Sydney Heritage Fleet Maritime Facility – Issues for Discussion

Further to our meeting this morning, this letter outlines the key flooding and climate change issues for discussion and clarification with the Proponent of the Sydney Heritage Fleet (SHF) maritime facility development.

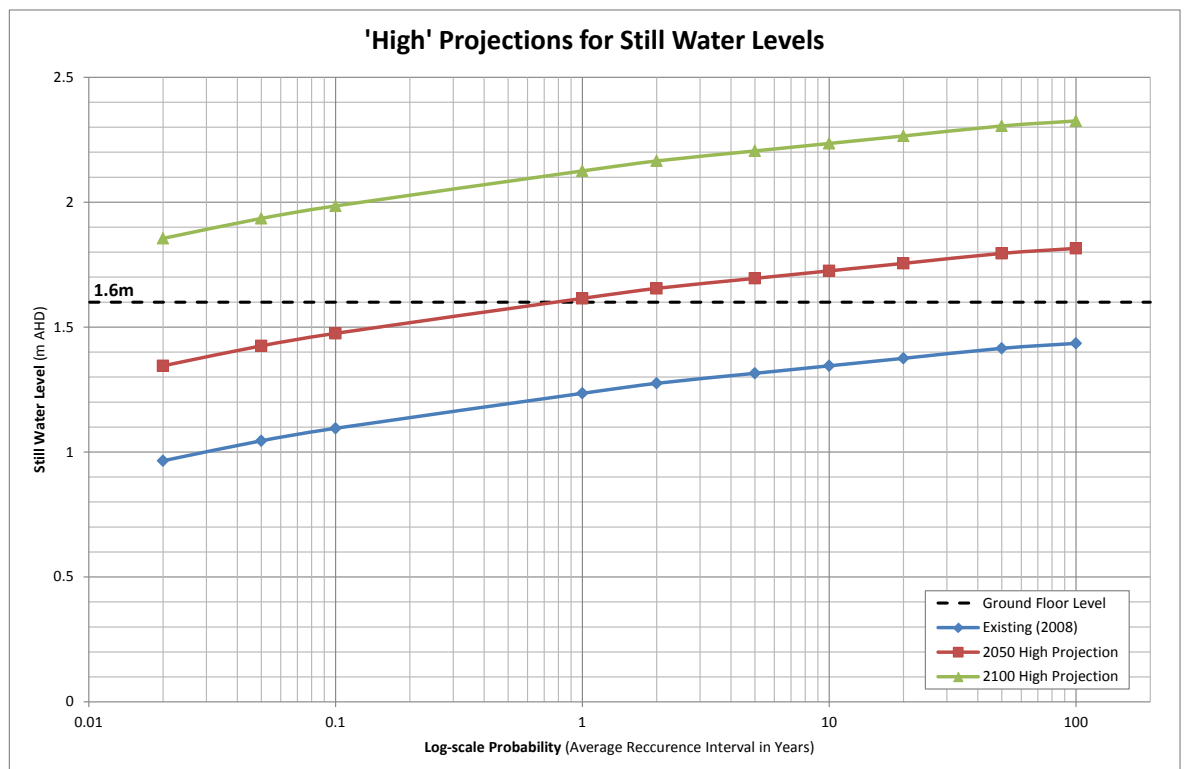
The predicted sea levels reported in both SLR reports are based on the existing sea levels for Fort Denison (*Fort Denison Sea Level Rise Vulnerability Study*, DECC, 2008) with allowance for these climate change increases in sea level, and include allowance for tide and storm surge effects. The figure below is based on data taken directly from the DECC report and shows projected sea level for different probabilities (expressed as average recurrence interval) for 2050 and 2100. For reference purposes, the figure also shows the proposed ground floor level (1.6 m AHD).

The data in the figure can be interpreted as follows:

- By 2030 there is a small risk (100 year average recurrence interval) that the water level in the harbour (without allowing for any wave effects) could be the same as the floor level.
- By 2040, the average recurrence interval would reduce to 6 years;
- By 2050, the average recurrence interval would reduce to less than 1 year.

The questions for SHF to consider are:

- What are the consequences of flooding on the building and its contents?
- What is an acceptable risk of flooding at some stage in the future?
- What, if anything should be done to manage or mitigate the risk at this stage?

As noted above, by 2050, the consequences of the current proposed floor level (1.6 m AHD) would be flooding from the harbour approximately once every year on average which would cause shallow flooding in:
